Subject: Issuance of Amendment No. 17 to Facility Operating License
NPF-9 - McGuire Nuclear Station, Unit 1

SAFETY EVALUATION BY THE
OFFICE OF NUCLEAR REACTOR REGULATION
RELATED TO AMENDMENT NO. 17
TO LICENSE NPF-9
DUKE POWER COMPANY

PART A: Dilution of Boron Concentration in the
 Boron Injection Tank

PART B: Containment Upper Compartment Temperature

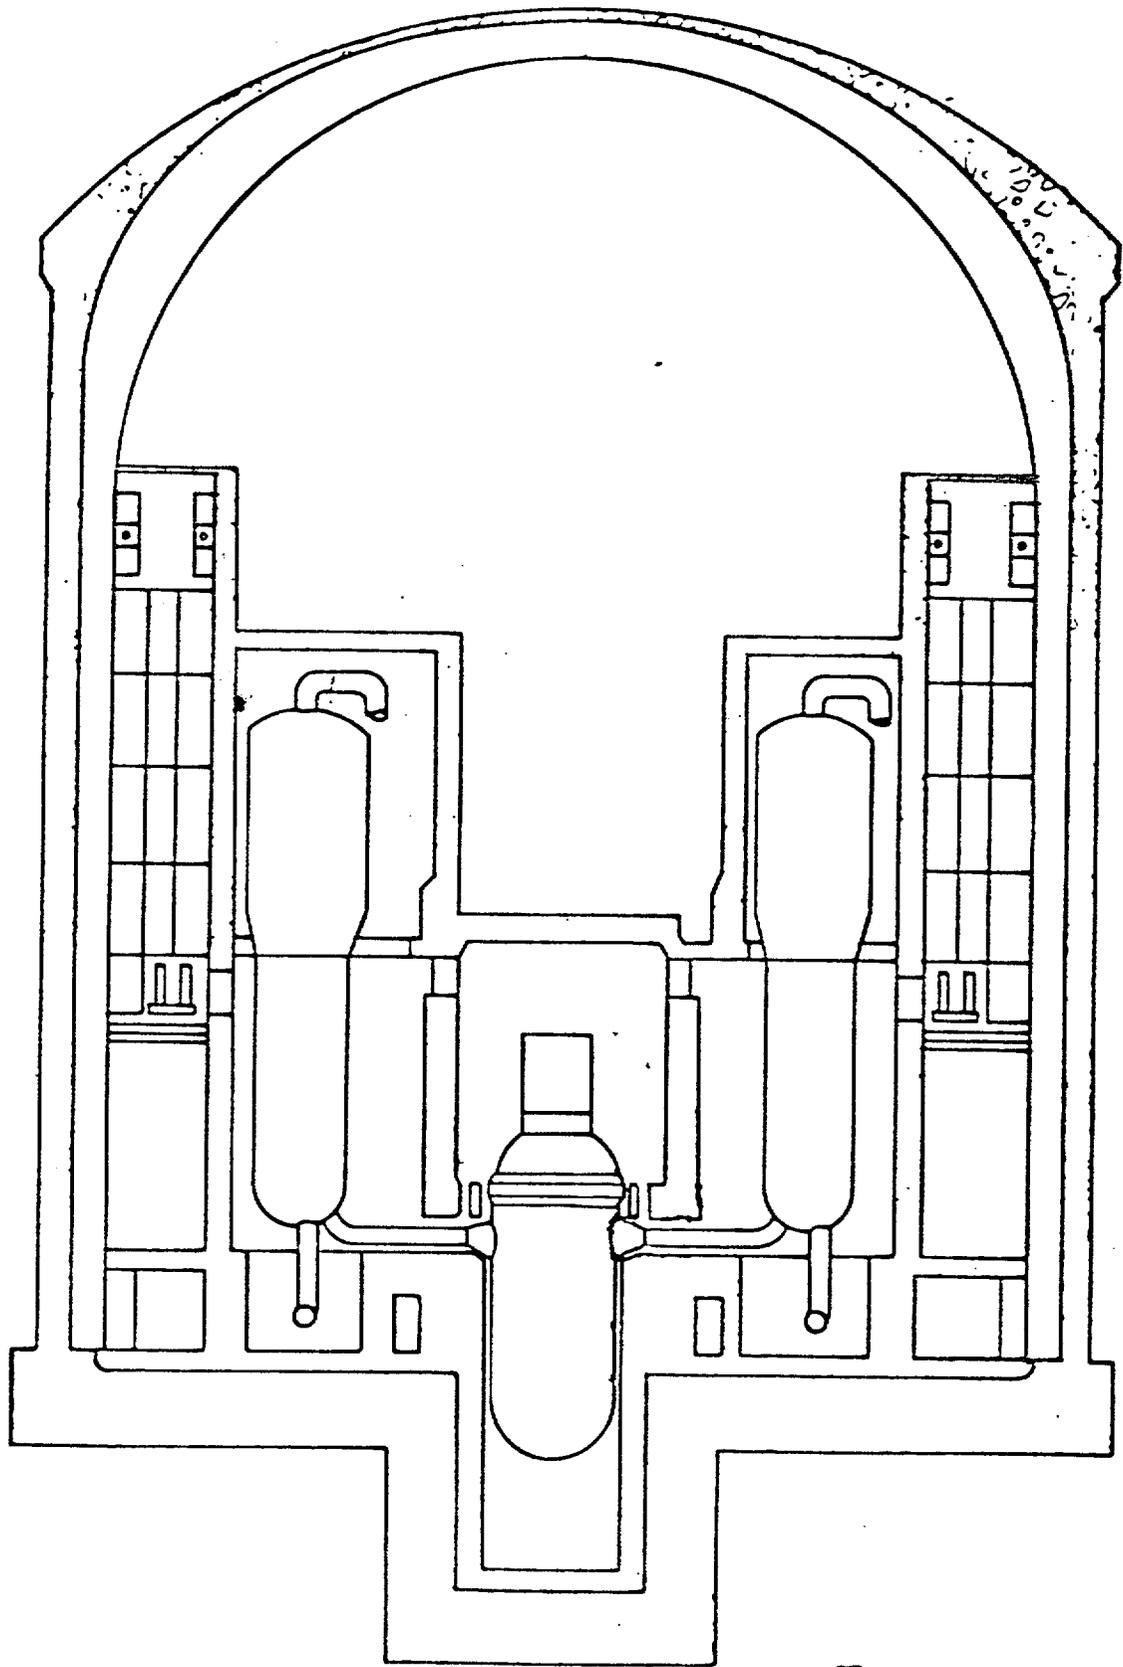
The McGuire Nuclear Station utilizes an ice condenser as a pressure mitigating system in containment. As shown on the attached figure the McGuire containment is physically divided into an upper and lower compartment. The barrier is designed to prevent steam from bypassing the ice condenser in the event of a postulated pipe rupture. Thus steam emanating from either a loss of coolant accident or a main steam line break inside containment will be forced to flow through the ice baskets which are located along the containment's perimeter. Since the steam resulting from a pipe break is largely condensed in the ice condenser, the containment internal design pressure is only 15 psig.

As stated previously the initial mass of air in containment can have a significant affect on the peak pressure transient calculation. This is particularly true for small containments incorporating low design pressures. By placing a technical specification limit on the minimum operating temperature, the initial mass of air present in containment is limited. If a large pipe break is postulated inside containment, the containment pressure is increased by both the partial pressure of steam and the partial pressure of air as it is heated and expands.

Since the limiting containment pressure calculations found in the McGuire FSAR consistently assume 75°F as the minimum upper compartment temperature, there is no loss of margin between the proposed technical specification and that found acceptable in the staff's Safety Evaluation Report. The current value of 85°F found in the McGuire Technical Specifications is unnecessarily conservative and has no apparent basis.

Based on our review of the licensee's submittal, we conclude that the proposed Technical Specification change reducing the minimum average air temperature in the primary containment upper compartment from 85°F to 75°F does not have any adverse effect on safety of plant operation or the health and safety of the public.
